# Access Compliance Report

## Public Rights-of-Way (Curb Ramps)

| Intersection ID: 53350 | Main Street: SAPPHIRE_HILL_LN | Cross Street: LOST_CANYON_WY | Location: W            |
| ADA ID: A040A1A1B7C7   | Ramp Type: BlendTrans1        | Initial Pass/Fail: Fail      | Overall Compliance: No |

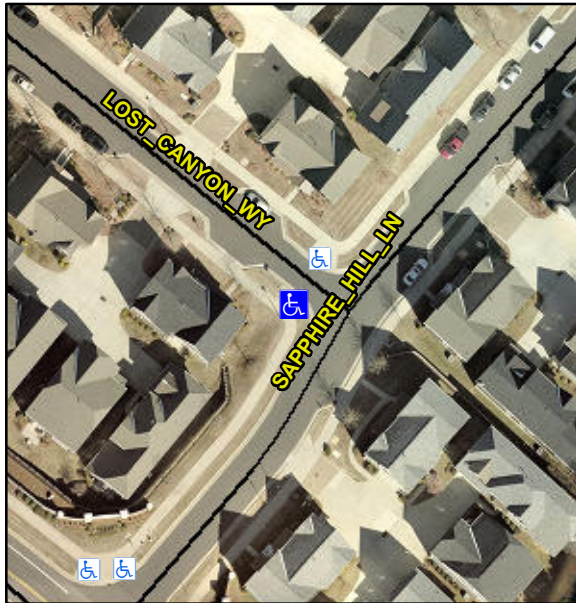
**Not Found, R304.5.3**

| Compliance | Description           | Data  | Compliance | Description                 | Data |
|------------|-----------------------|-------|------------|-----------------------------|------|
| Yes        | Ramp Width (in)       | 60.0  | No         | BlendTrans XSlope (%)       | 7.9  |
|            |                       |       | No         | Curb Slope (%)              | 11.7 |

**Remove & Replace Curb Ramp With Two New Directional Ramps or Equivalent.**
